Low Level Road Feedback

Vancouver Area Cycling Coalition
Presentation to City of North Vancouver Council
April 18, 2011

Speed Controls

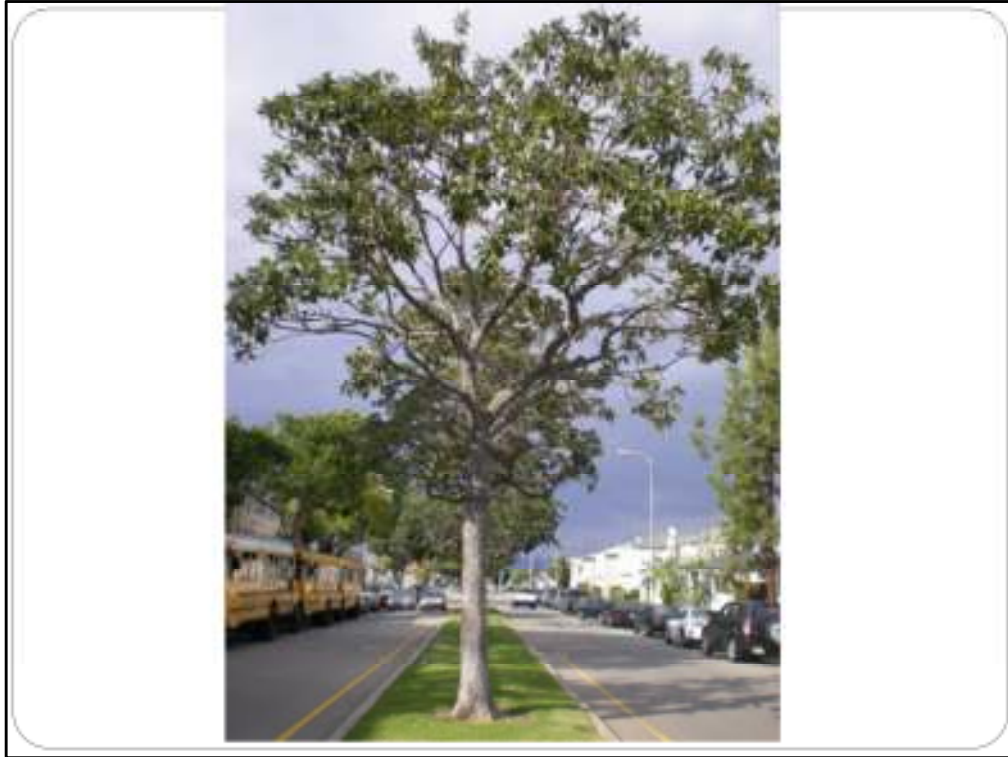
This design makes the new road look like a highway.

Building a long straight roadway with good site lines means people will speed up.

What can be done to reduce vehicle speeds to increase safety and reduce noise, and pollution?

There is no room for bump outs or rest areas, unless the pedestrian side walk is cantilevered (which was in one of the options).

However Can we make this new road more appealing aesthetically, safer for cyclists and reduce traffic speeds?

Maybe the physical barriers could be green barriers such as slim trees?
